Response to Submissions

330 Church Street, Parramatta

MP10_0171 MOD 3

26 September 2013

Figure 1: Riverbank Site Data vision for the locality

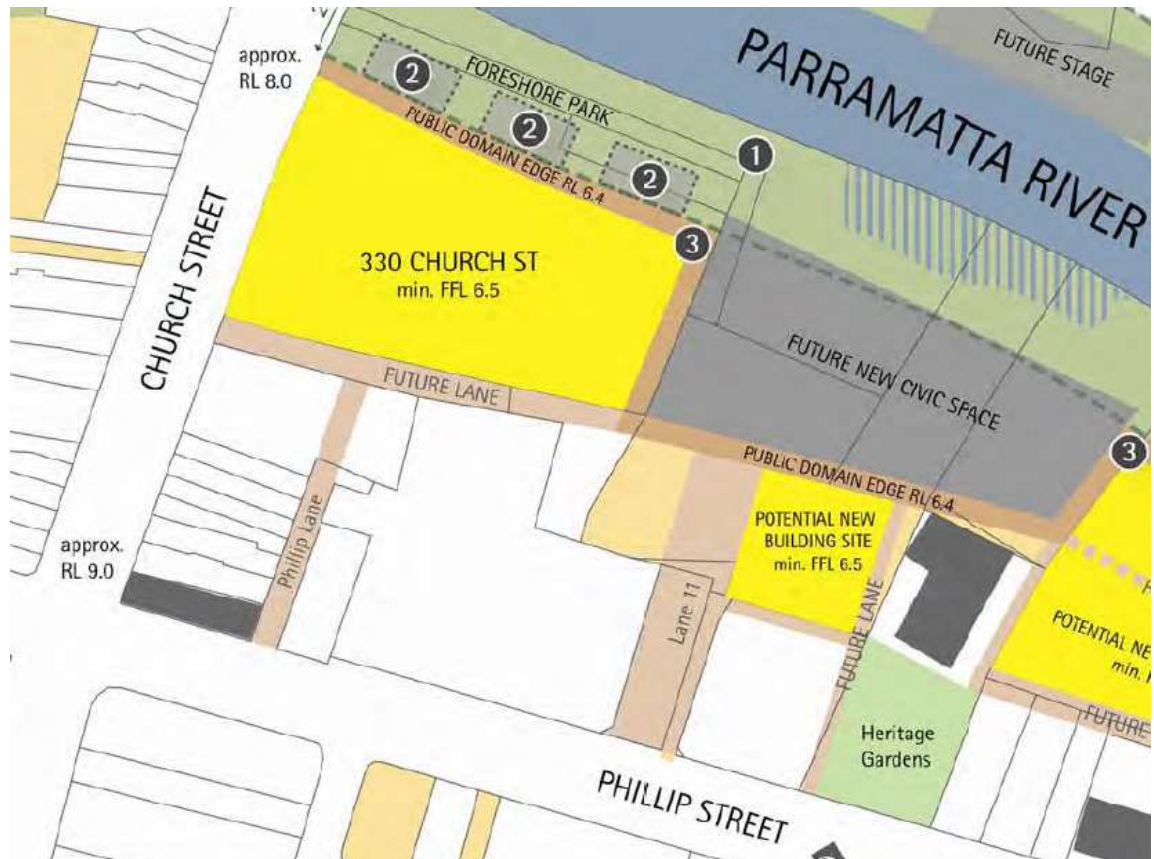
The department is concerned that the design of the driveway entry to the site will result in vehicular and pedestrian conflicts on land that will be redeveloped by the council as a future public square. Additional details should be provided to identify how the driveway located on the south-east corner of the site will be designed to ensure that these conflicts are minimised. The information submitted to address this issue must include:

- *A site plan which extends to Phillip Street which illustrates how pedestrians will obtain access from the footpath to the lobby entrance; and*
- *Plans depicting the location of all security gates/roller doors and card readers.*

The Council's proposed future square is situated to the east of the subject site, as shown in **Figure 1**. All vehicular access will occur south of the public domain edge shown on the plan. The same applies to pedestrian traffic between the site and Phillip Street. Accordingly, no conflicts will occur between the future city square and pedestrian and vehicular access for the site.

Figure 2: Cadastral map of locality

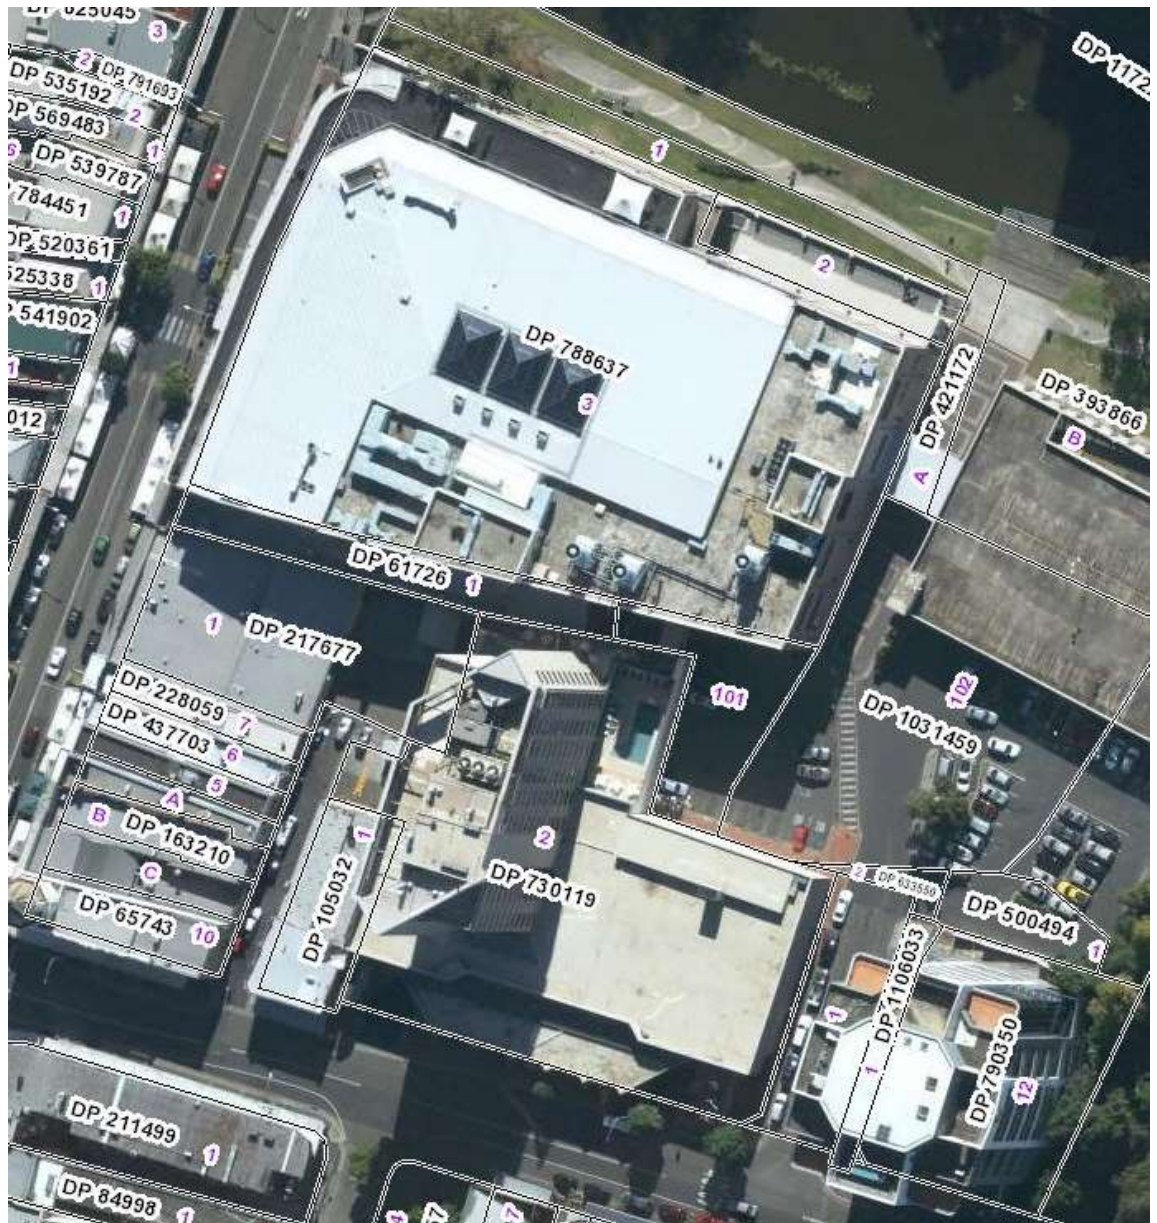
The department also has concerns regarding the impacts of the proposed basement access arrangements on the adjoining landowner at 328 Church Street. The RTS/PPR should address how these impacts will be managed to ensure a suitable level of access is provided to the adjoining landowner.

Figure 2 below shows the cadastral information for the subject site and its surroundings. It shows that 328 Church Street (Lot 1, DP 61726) backs onto Lot 101, DP 1031459 being part of the subject site. A search of the current land title information reveals that 328 Church Street has a right of access over Lot 101, DP 1031459. The MOD3 does not seek to change this.

The design of the MOD3 plans will improve accessibility to the owner's property because all truck manoeuvring is proposed to occur within the building, rather than outside the building as originally approved.
